Pentium[®] II Processor Specification Update

Release Date: March 11, 1998

Order Number: 243337-012

Figure 23. Processor with an Example Low Profile Heatsink Attached using Spring Clips

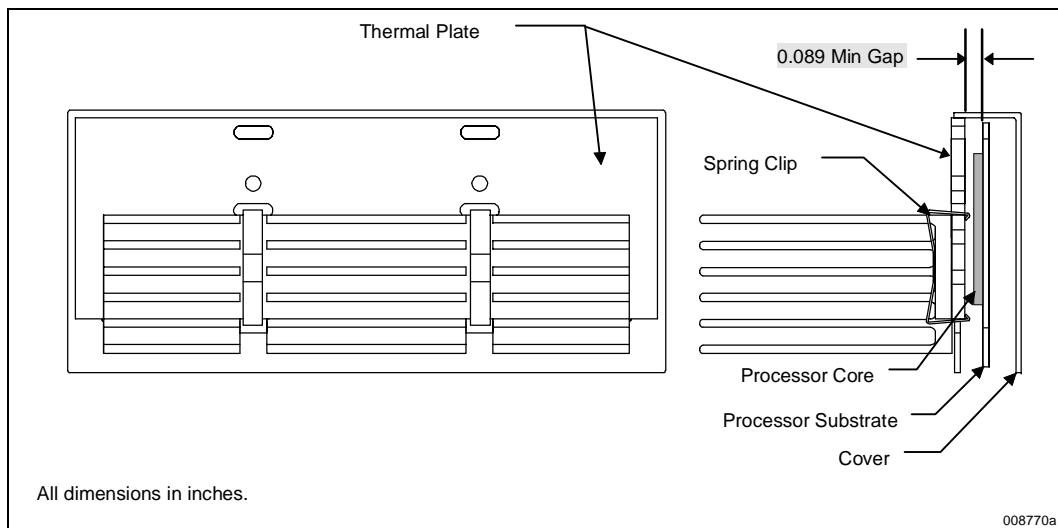
Figure 23 and Figure 24 illustrate example clip designs to support a low profile and a full height heatsink, respectively. The clips attach the heatsink by engaging with the underside of the thermal plate. The clearance of the thermal plate to the internal processor substrate is a minimum **0.089"** (illustrated in Figure 23 and Figure 24). The clips should be designed such that they will engage within this space, and also not damage the substrate upon insertion or removal. Finally, the clips should be able to retain the heatsink onto the thermal plate through a system level mechanical shock and vibration test. The clips should also apply a high enough force to spread the interface material for the spot size selected.

Figure 26. Heatsink Rivscrew* and Thermal Plate Recommendations and Guidelines

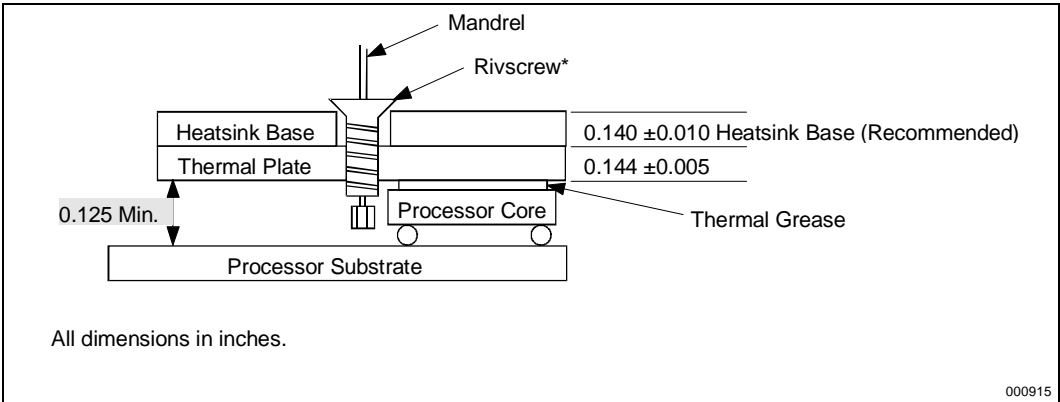
The Rivscrew attach mechanism uses a specialized rivet that is inserted through a hole in the heatsink into the thermal plate. Upon insertion, a threaded fastener is formed that can be removed if necessary. For Rivscrew attachment, the minimum gap between the thermal plate and the processor substrate is **0.125"**. For use of the Advell Rivscrew (part number 1712-3510), the heatsink base thickness must be $0.140 \pm 0.010"$. See Figure 25, Figure 26 and Figure 27 for details of heatsink requirements for use with Rivscrews.
